TERRA RIDGE NORTH CIVIL CONSTRUCTION PLANS El Paso County, Colorado

V2_Construction Drawings Redlines.pdf Markup Summary 3-20-2023

Glenn Reese - EPC Stormwater (23)

EL PASO COUNTY DEVELOPMENT
REPLAT TERRA RIDGE LOTS 5 & 6 W/ 11 LOTS IN
TERRA RIDGE NORTH
OUTLET STRUCTURE DETAILS

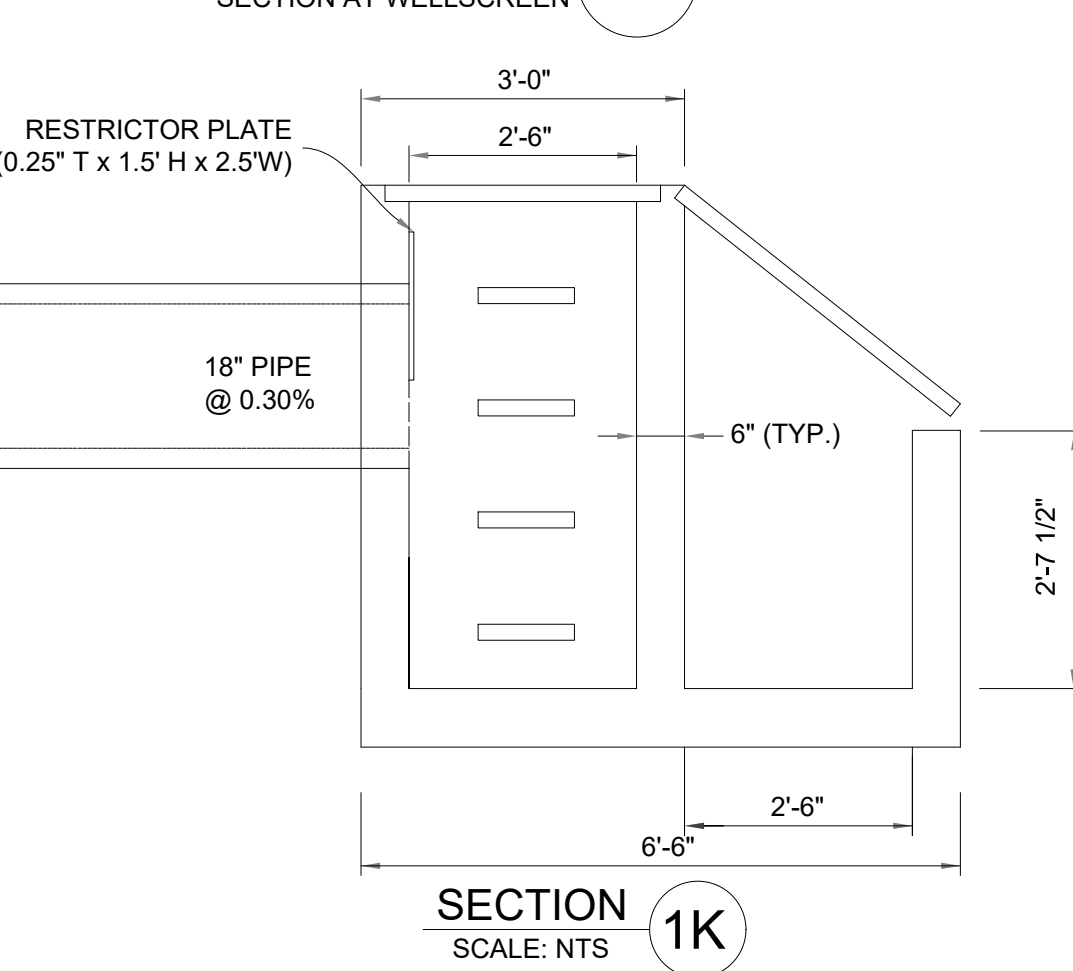
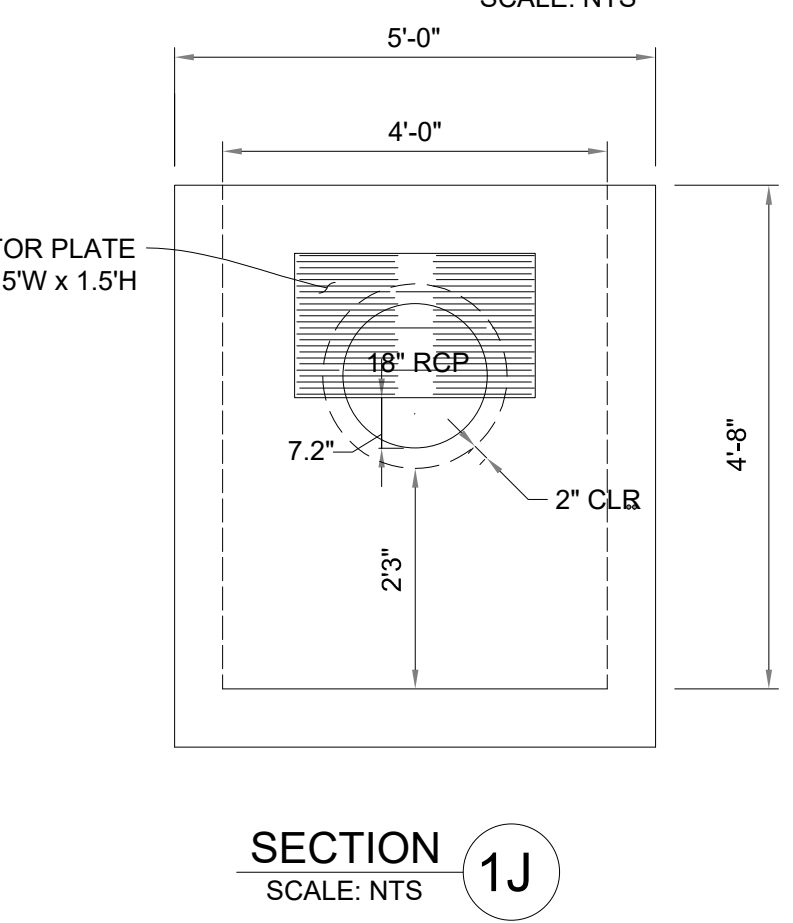
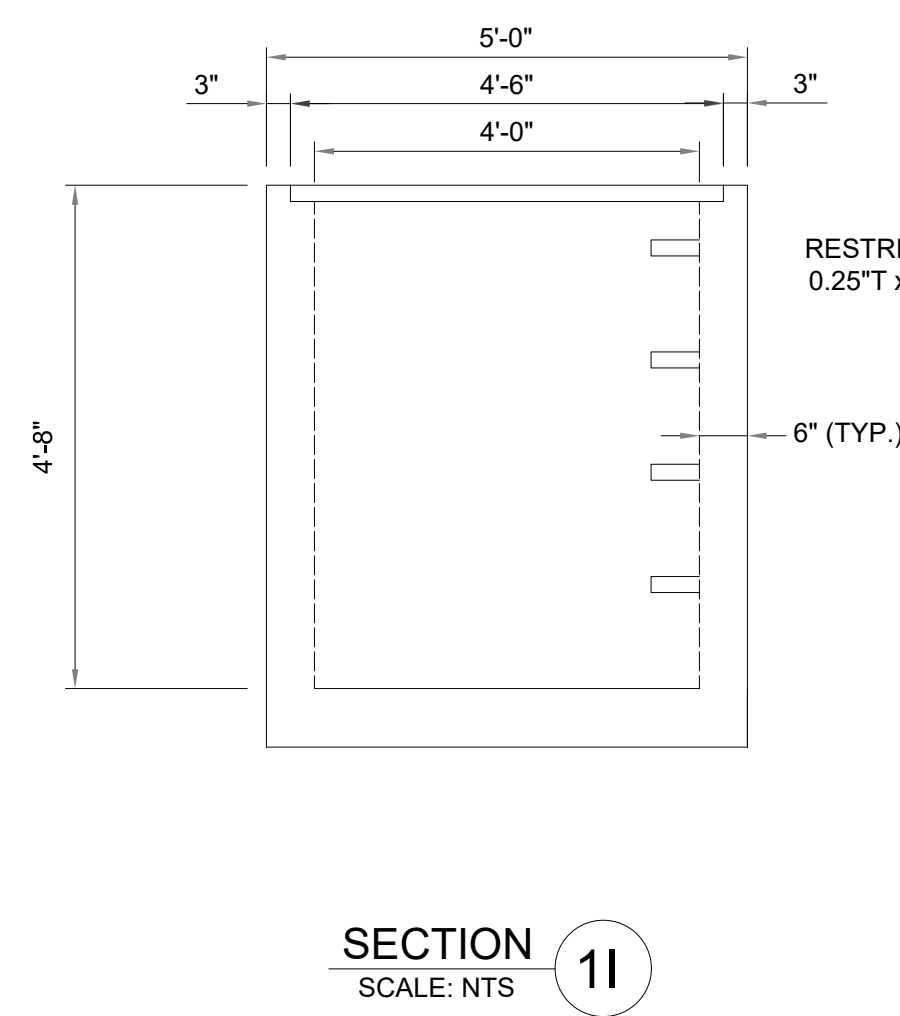
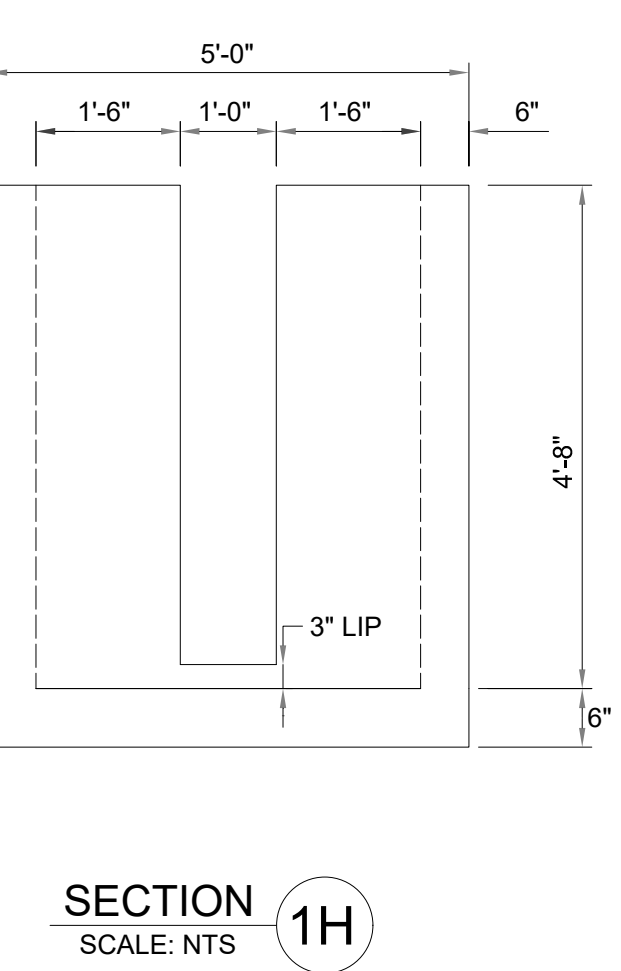
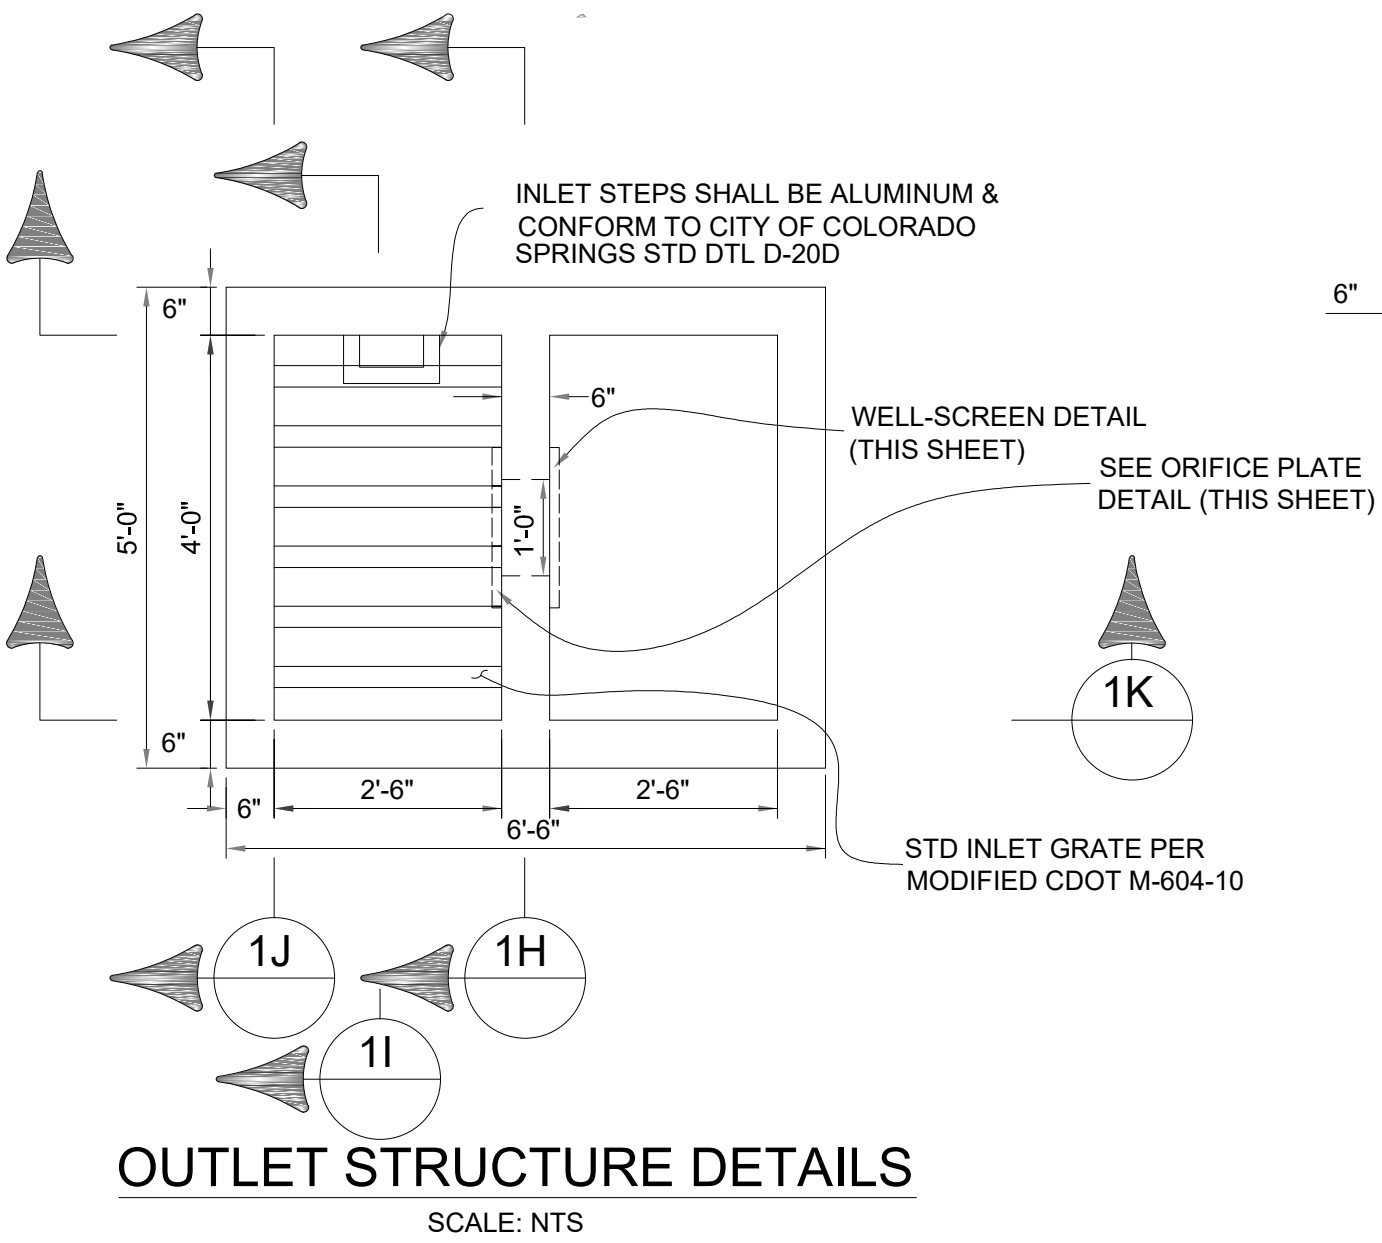
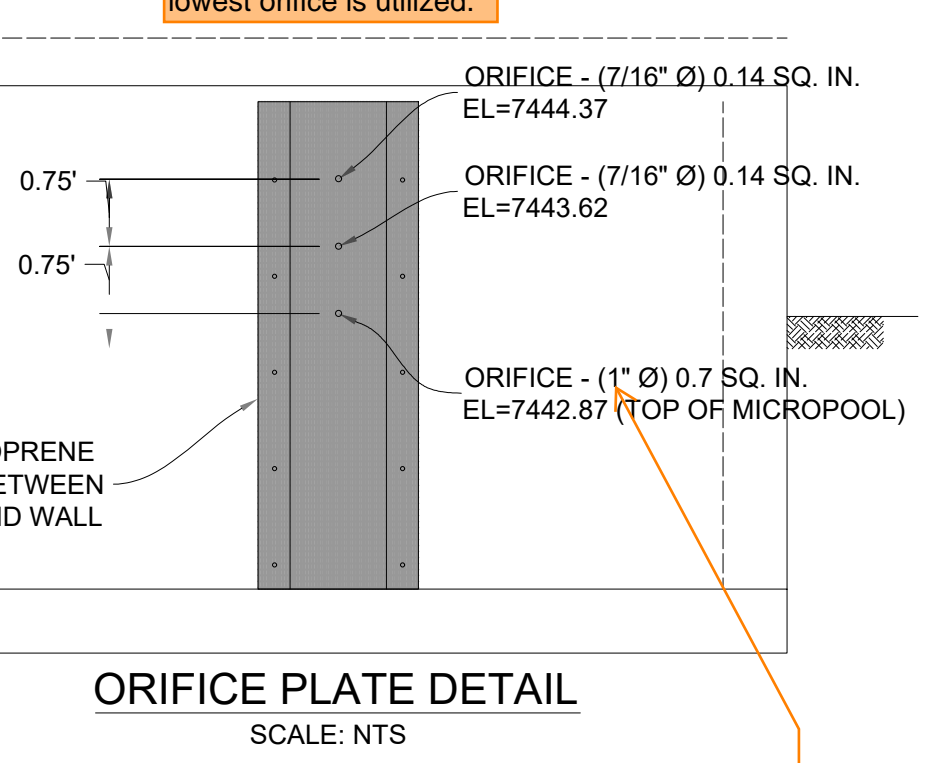
Text on pdf page 9 of FDR states that this is 15/16" diameter. Revise to remove discrepancy.

this label is unclear. What are the two arrows pointing to? The top of concrete at the flowline and also at the top of the outside edges? Please clarify. Or just label flowline.

How this detail is currently shown, it is unclear if a 4" initial surcharge volume is provided in the micropool or not. Please revise to clearly show a difference of 4" from the flowline of the trickle channel at its terminus at the micropool to the WSE. Meaning that there micropool will fill up by 4" before the lowest orifice is utilized.

Unresolved. provide information for the grate to be installed on the second chamber
